Groundwater and Wastewater Services File Imaging Project

IMPROVEMENT PERMIT for a RESIDENTIAL ON-SITE WASTEWATER TREATMENT & DISPOSAL SYSTEM

SEPTIC SYSTEM DESIGN REVIEW WORKSHEET

RE: Request for an Improvement Permit for Lot 16 off of Sample Road.
MCHD File #6754B

Scale: 1 inch equals 50 feet	S&ME	Faison-Sample Road, LLC	FIGURE
Drawn by: JBP		Lot 16	1
Reviewed by: Jeremy P. Michelone, RS		Mecklenburg County, NC	
Date: March, 2007	ENVIRONMENTAL SERVICES · ENGINEERING · TESTING	S&ME Project #1588-05-091

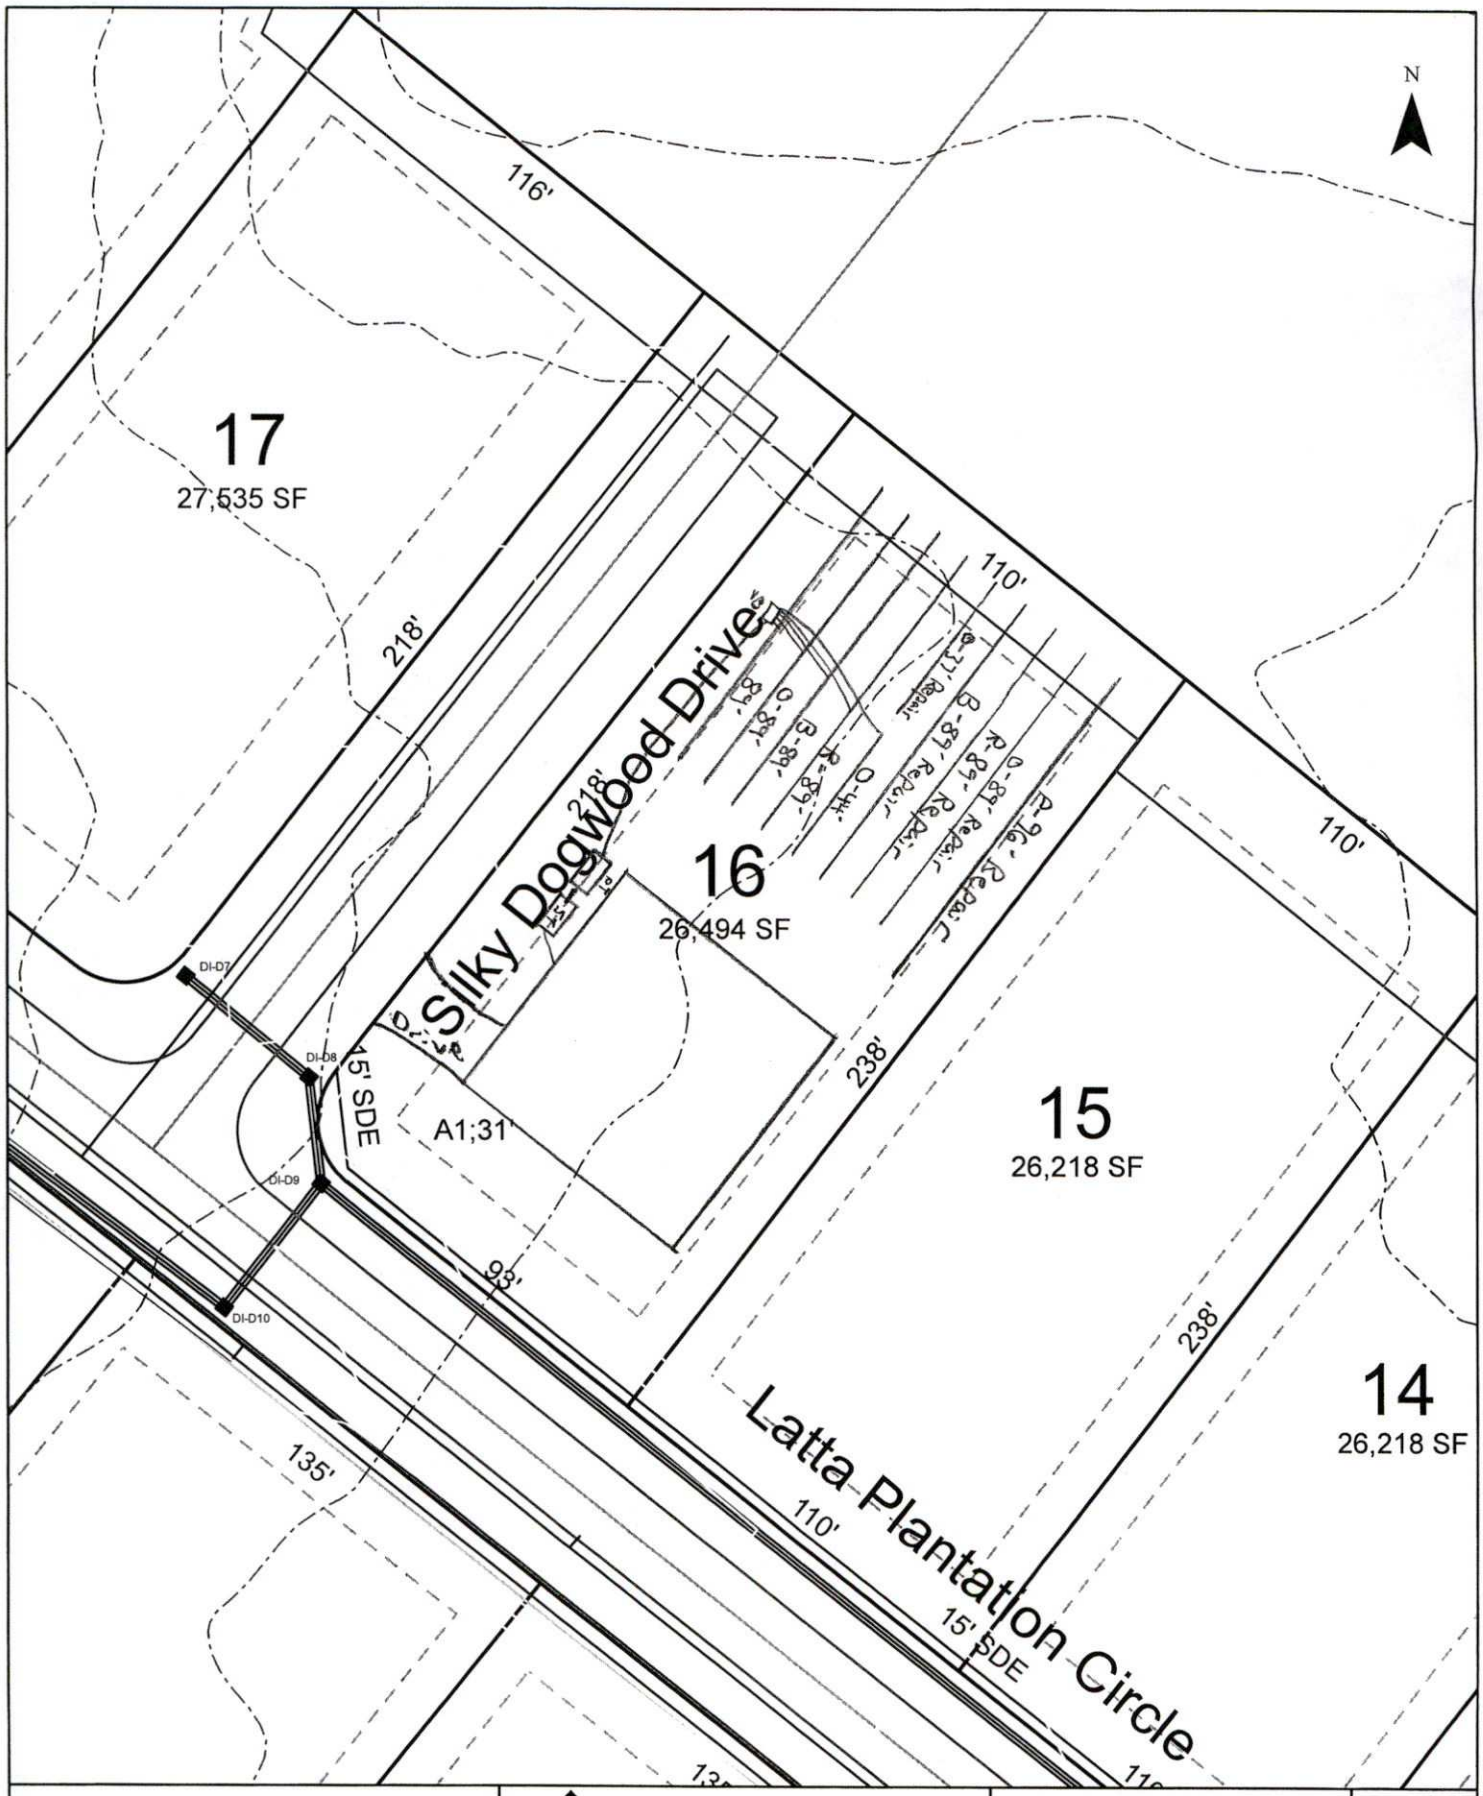
2. Number and length of laterals and number of T&J Panels do not match on design specification sheet.

Daily Design Flow:	600 gpd
Number Bedrooms:	5 bdr.
Basement or Crawlspace:	Crawl Space
Septic Tank Size:	1500 gal
Pump Tank Size:	1500 gal
Primary System Loading Rate:	**0.25 gpd/ft^2**
Primary System:	**LP PPBPS**
Number and length of laterals:	4 lines @ 89 ft. centerfed 1 line @ 44 ft. endfed
Total ft. of primary system:	400 ft. (400' required)
Number of T&J Panels:	4 lines @ 45 ft., 10 panels each (40 total) 5 lines @ 44 ft., 10 panels each (50 total) Total of 90 panels
Flow Rate through system:	45 gpm – use 5/32 in. holes with 3 ft. head pressure
Pump Requirements:	to be calculated by installer when specific house and pump tank locations are available
Dosing Volume:	approx. 324 gal. – (3.6 gal per panel)* 1.85 doses/day
Depth of effluent pumped per dose:	calculated to specific tank by measure or dealer engineering specifications (1 cubic ft. of water equals 7.48 gal.)
Check Valve:	yes
Siphon break hole:	yes

Sketch of Soil Evaluation Locations

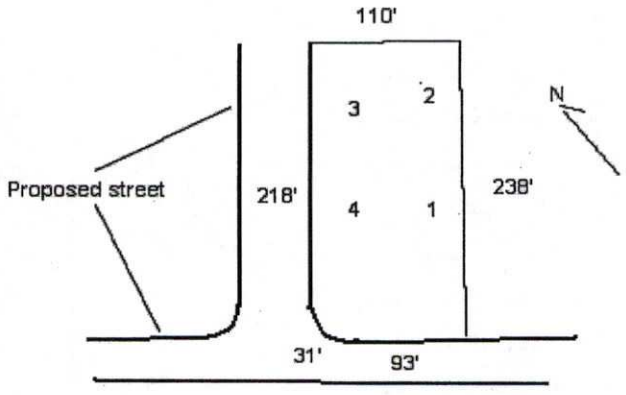
1. Soil report and application needs to be updated to show review for 5 bedroom house (600 GPD).

Owner: Faison- Sample Road LLC
Applicant: S & ME- Toney Jacobs
Address: 121 W. Trade St., 27th Floor, Charlotte, N. C. 28202-5399
Date Evaluated: 12/13/06
Proposed Facility: Residence
Design Flow (.1949): ~~480gpd~~ 600gpd
Property Size: .61a
Location of Site: Off Sample Road
Property Recorded:
Water Supply: [x] Public [ ] Individual [ ] Well [ ] Spring [ ] Other
Evaluation Method: [x] Auger Boring [ ] Pit [ ] Cut
Type of Wastewater: [x] Sewage [ ] Industrial Process [ ] Mixed
